SERVICE BULLETIN 9B

SUBJECT: Nose Gear Shimmy

APPLICATION: All Glasair RG aircraft.

FIGURE (1)

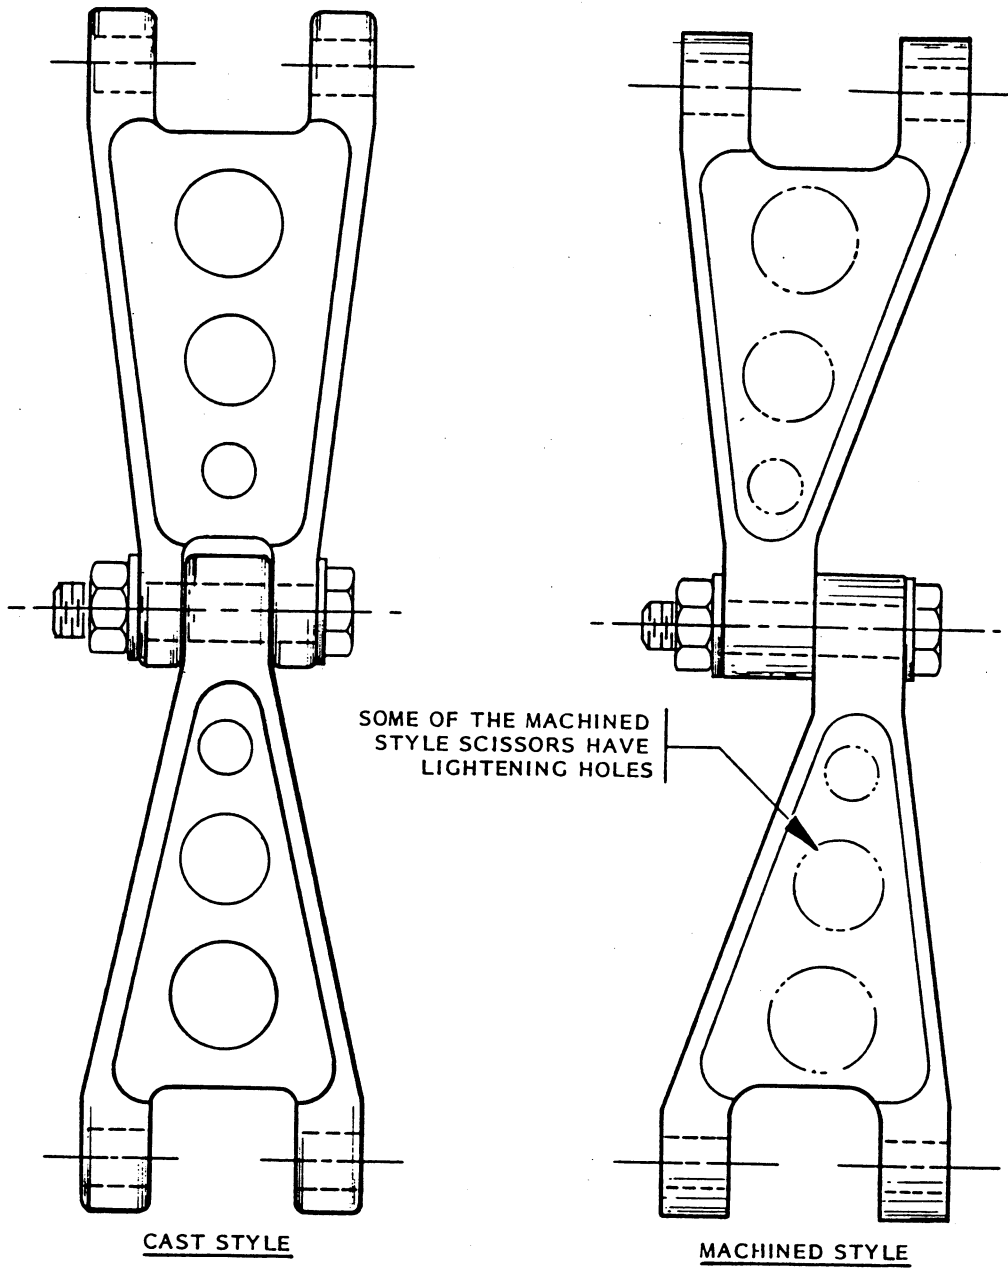
Another possible source of play in the nose gear assembly is the Nyliner bushings used in the scissors pivot joints. If you are continuing to experience nose gear shimmy, and you have eliminated all the other potential causes discussed in Service Bulletin 9, you may want to consider replacing the Nyliner bushings in your nose gear scissors with aluminum bronze bushings.

On our 180 hp RG model, N84AG, we replaced the Nyliner bushings in the nose gear scissors with aluminum bronze bushings and noticed less play in the pivot joints. It is still inconclusive whether this procedure is necessary to help eliminate shimmy, but we mention it in case someone else with shimmy problems wishes to try it. We used NAS76A bushings and cut them to the proper lengths.

To press the aluminum bronze bushings into place, the scissors must first be drilled and reamed to accommodate the larger outside diameter of the bushings.

CAUTION: It is very critical when drilling and reaming the scissors for the larger bronze bushings that proper alignment is maintained and the scissor lugs are not flexed. A drill fixture should be made to hold the scissors and a specially ground pilot ream should be used. It is very likely that the scissors could be ruined if these holes are not properly drilled.

Two types of scissors have been used on Glasair RGs, as illustrated in FIGURE (1). An aluminum insert was used with some of the machined style scissors, allowing the aluminum bronze bushings to be pressed into place without any drilling or reaming.

FIGURE (2)

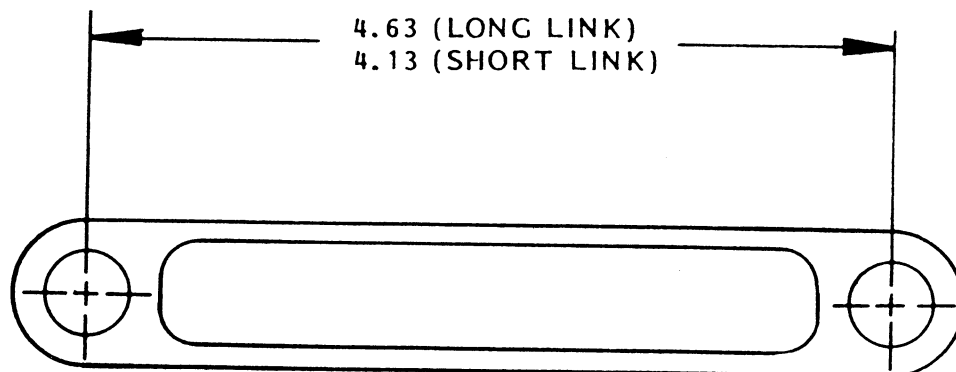
The installation of a longer drag link may have had the effect of reducing nose gear shimmy on one Glasair RG with which we experimented. The longer drag link was standard equipment in the first 70 sets of RG landing gear but we went to a shorter link on later gear to make the airplane easier to steer. The effect of the longer link when the gear is extended is to angle the strut out farther toward the front slightly, increasing the amount of caster which may tend to stabilize the nose wheel.

To determine if you have the longer or shorter drag link, measure between the centers of the two drag link pivot bolts, as shown in FIGURE (2). The short link is 4.13 in. between pivot centers; the longer link is 4.63 in. between centers, as shown.

FIGURE (3)

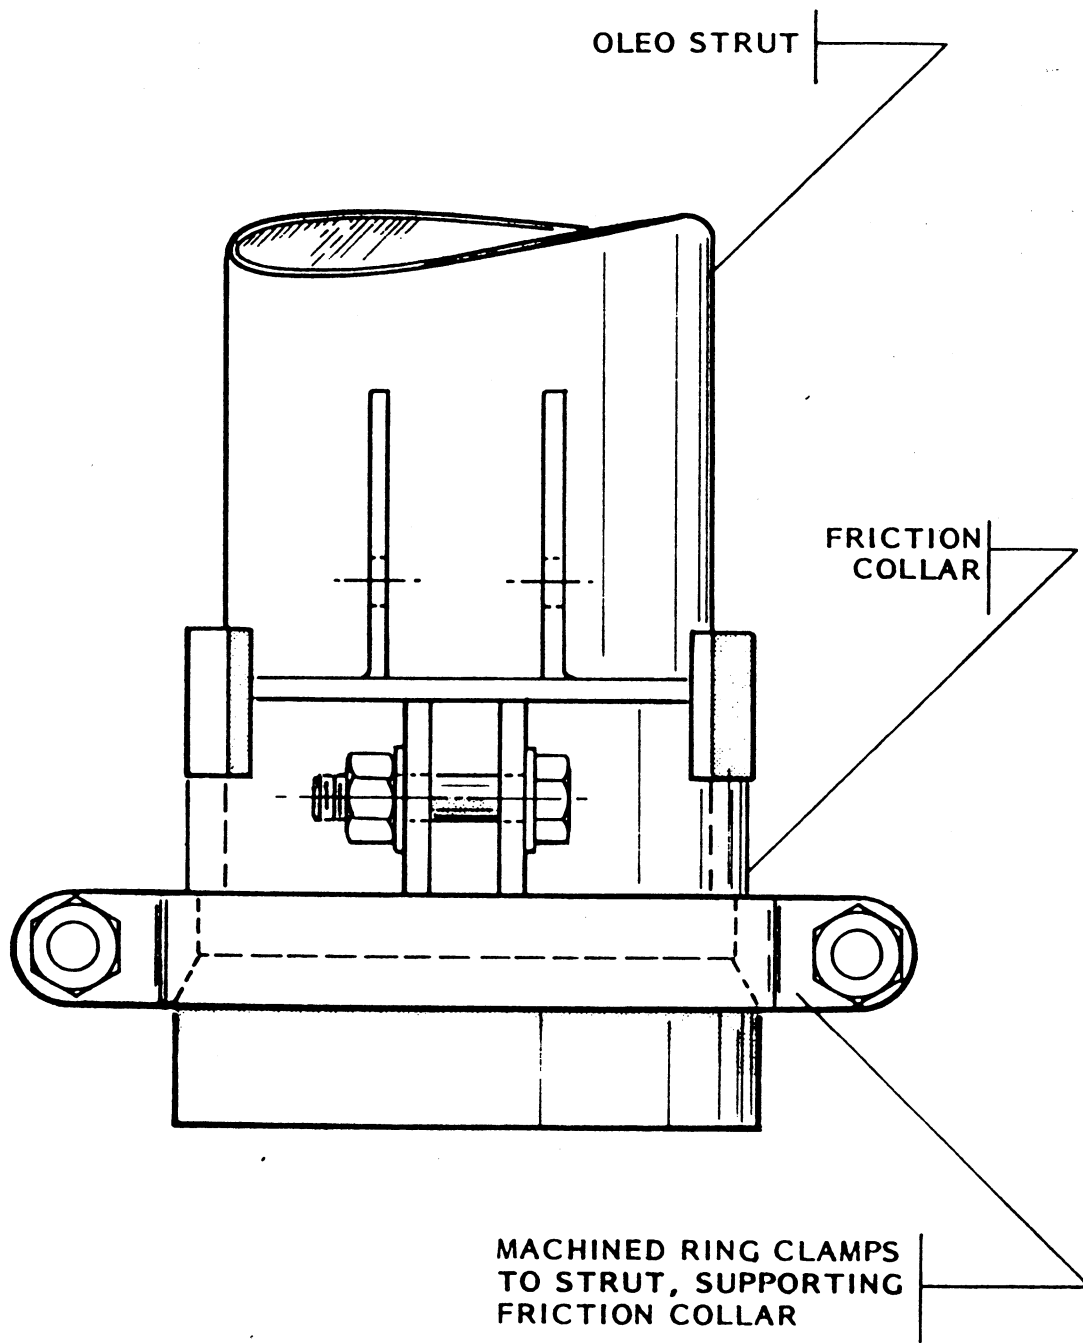
Another area of possible contribution to shimmy is "racking" of the friction collar clamps. The lower edge of the friction collar is chamfered to clear the cylinder/gland weld which allows the collar to rack slightly when load is applied. Ideally, the collar needs to be captured snugly in a recess.

A possible method of stabilizing the friction collars is a lower clamping ring for the nose gear oleo strut. This ring would clamp around the strut just below the friction collar recess and would provide a surface for the collars to bear against, preventing the collars from racking under load. See FIGURE (3) for a clarification of this concept.
